STAFF REPORT
KETCHUM PLANNING AND ZONING COMMISSION
MEETING OF SEPTEMBER 9, 2025

PROJECT: The Bitterroot

FILE NUMBER: P25-020

APPLICATION: Pre-Application Design Review

Figure 3: Side Facade Visible from Sun Valley Rd Concerns

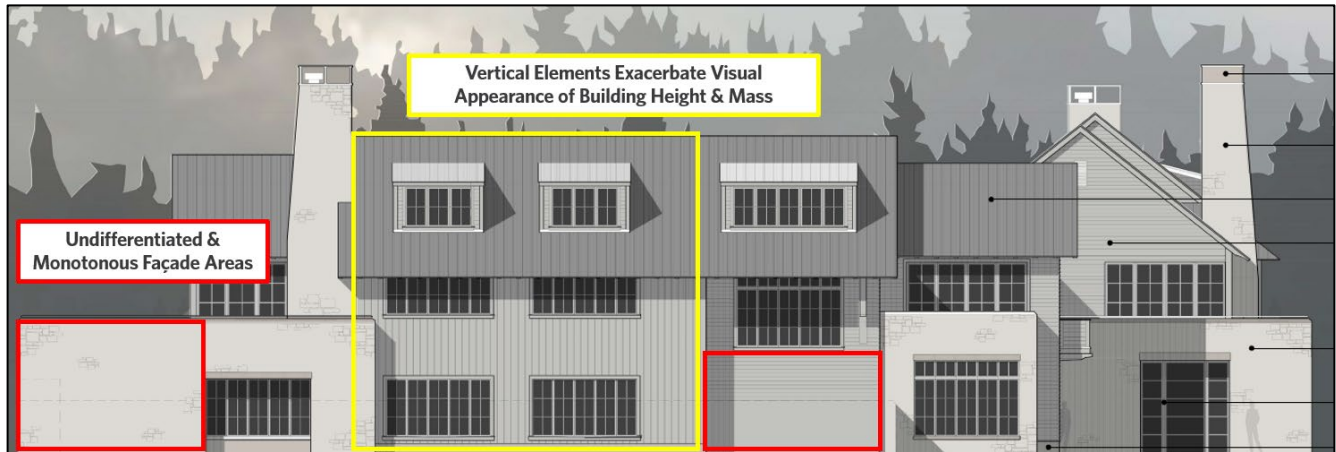
Pursuant to KMC §17.96.060.F.5, building walls shall provide undulation and relief to reduce the appearance of bulk and flatness. While the subject property, does not have street frontage along Sun Valley Road, this elevation is exposed as the adjacent properties include a single-story building and surface parking lot. As shown in Figure 3, portions of the building wall visible from Sun Valley Road appear monotonous and flat. In addition Staff believes the vertical standing seam roof, vertical wood siding, and vertical window lentils exacerbate the building's height and mass at this elevation. Staff recommends the applicant consider design changes that provide visual interest and help animate the side façade that is visible from Sun Valley Road.

Figure 5: Exterior Material & Color Palette

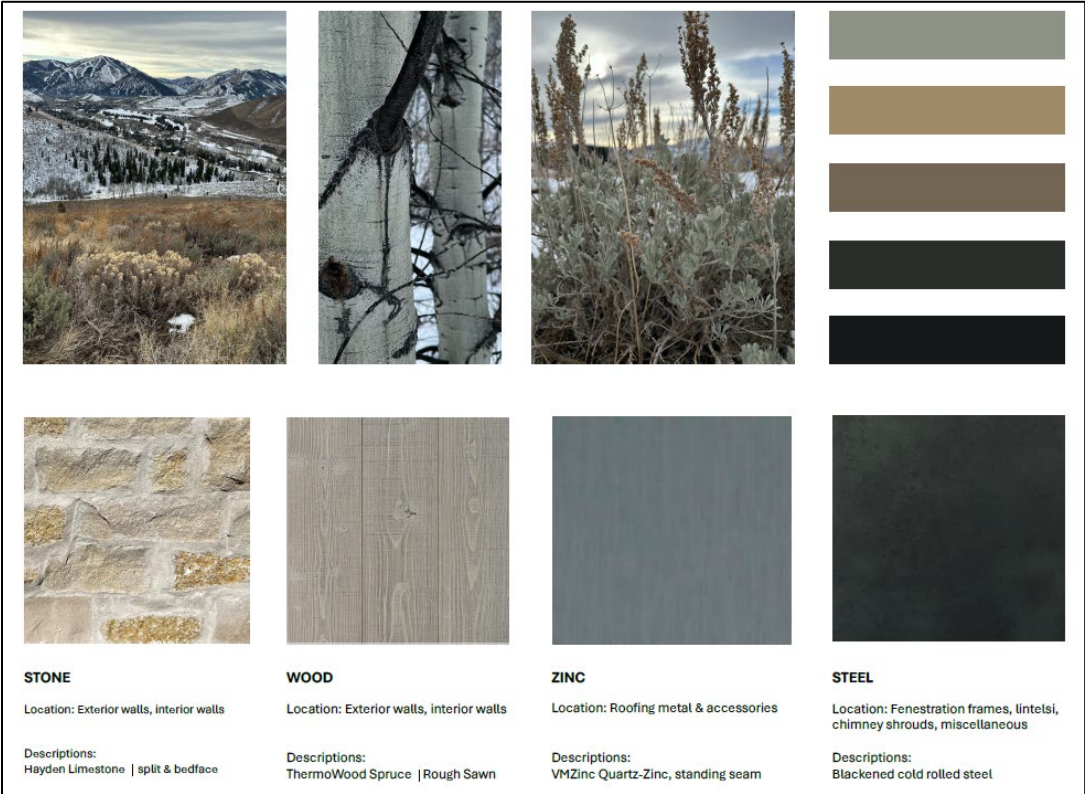
Pursuant to KMC §17.96.060.E1, “The project’s materials, colors and signing shall be complementary with the townscape, surrounding neighborhoods, and adjoining structures.” The proposed exterior material and color palette is provided on page 6 of the drawing set (see Attachment A and Figure 5). The proposed exterior materials include Hayden Limestone, rough sawn ThermoWood Spruce wood siding, a zinc standing seam roof, and blackened steel fenestration frames, window lintels, and chimney shrouds. Inspired by the winter and fall seasons, the proposed exterior material palate is comprised of cooler color tones. Staff is concerned that the proposed colors may appear cold and stark. Staff is also concerned that the similar color tones of the primary stone and wood materials will make the building walls appear more monotonous and flat.

During city department review, staff recommend the applicant consider the following design changes: (1) add warmer color tones into the exterior material palette, (2) incorporate more obvious changes in exterior materials, colors, and architectural details to add visual interest, and (3) include exterior materials with detailing, depth, and patterns to animate the facades. The applicant did not propose any changes or revisions in response to staff’s recommendations stating that:

The design team has worked hard to identify a color palette and exterior material scheme that aims to both blend with the area of the town and also honor the natural context given its proximity to

Trail Creek. The color palette has been modeled after some fall and winter colors observed from the trees and shrubs around the property.

PROPOSED ELEVATION - SPRUCE STREET

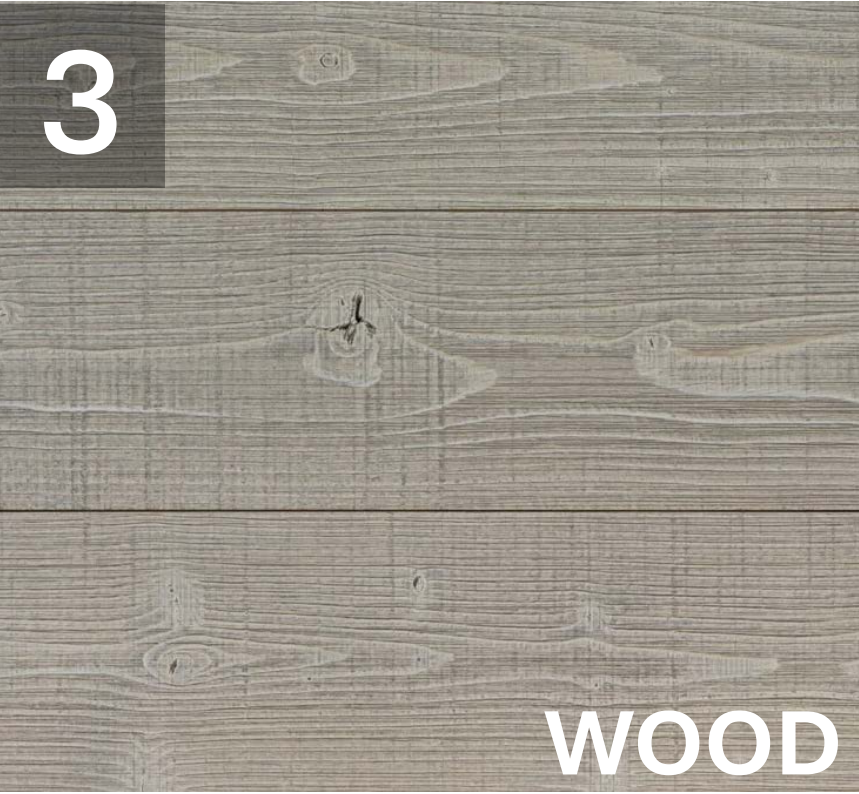
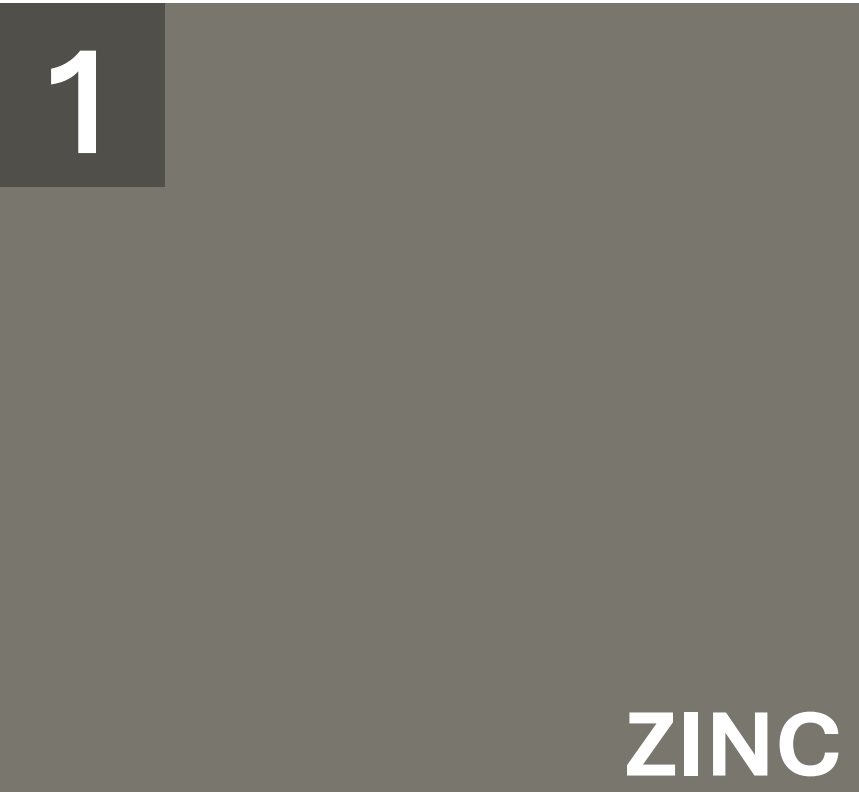
Staff has concerns about the design of the front elevation along Spruce Avenue and north side wall visible along Sun Valley Road. These concerns as well as staff’s recommendations are detailed in the Design Review analysis section below.

KMC §17.96.060.F1 requires that, "Building(s) shall provide unobstructed pedestrian access to the nearest sidewalk and the entryway shall be clearly defined." As shown in the massing model on page 14 of the drawings (see Figure 4), entrances to the residential lobby and commercial space are frame the outdoor plaza area along Spruce Avenue. The entrance to the residential lobby is covered by a cantilevered deck that extends from the second floor above. The commercial space includes the same fenestration design as the residential space but the windows are larger and taller. The commercial space is clad in stone, which helps differentiate the commercial space from the residential use that is clad in wood siding. While the stone helps define the commercial space, staff recommends the applicant consider design treatments to further distinguish the commercial space and make its entrance more prominent along Spruce Avenue.

gathering space. In addition to making the commercial entrance more prominent, staff recommends the applicant consider lowering the exterior plaza to be level with the sidewalk along Spruce Avenue. Public gathering spaces on private property are more welcoming when they are level with the sidewalk. Staff also recommends the applicant consider adding more pedestrian amenities like outdoor seating/benches.
